FORM APPROVED
OMB NO. 1004-0135
Expires: July 31, 2010**SUNDRY NOTICES AND REPORTS ON WELLS**
*Do not use this form for proposals to drill or to re-enter an abandoned well. Use form 3160-3 (APD) for such proposals.*5. Lease Serial No.
NMLC029339A

SUBMIT IN TRIPLICATE - Other instructions on reverse side.8. Well Name and No.
JACKSON A 279. API Well No.
30-015-3476510. Field and Pool, or Exploratory
CEDAR LAKE GLORIETA YESO

DRILLING PLAN
Jackson A 27 Deepening

Jackson A 27
30-015-34765
Burnet Oil Co.
March 28, 2014
Conditions of Approval

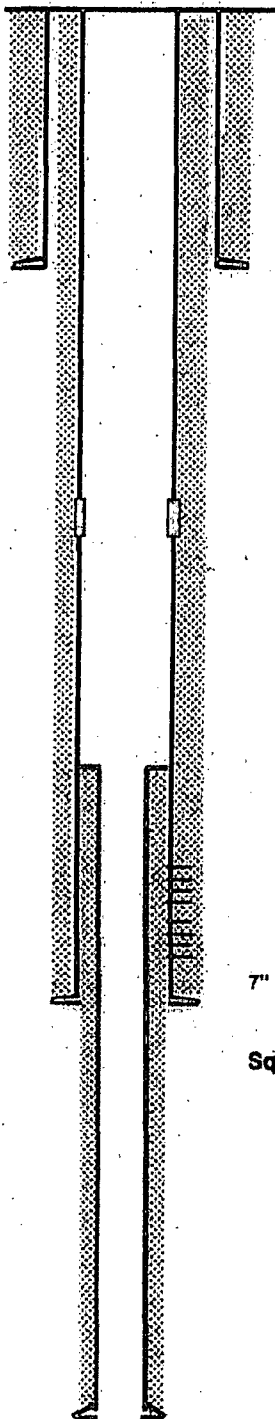
See COA The blowout prevention equipment (BOPE) shown in **Exhibit H** will consist of a 2000 PSI Hydril Unit (annular) with hydraulic closing equipment. The equipment will comply with Onshore Order #2 and will be tested to 50% of rated working pressure (RWP), and maintained for at least ten (10) minutes. The 7" drilling head will be installed on the surface casing and in use continuously until total depth is reached. An independent testing company will be used for the testing. Other accessory BOP equipment will include a Kelly cock, floor safety valve, choke lines and choke manifold having 2000 PSI WP rating.

5. BOP to be tested to **2000 psi** based on BHP expected. **In the case where the only BOP installed is an annular preventer, it shall be tested to a minimum of 2000 psi (which may require upgrading to 3M or 5M annular).**
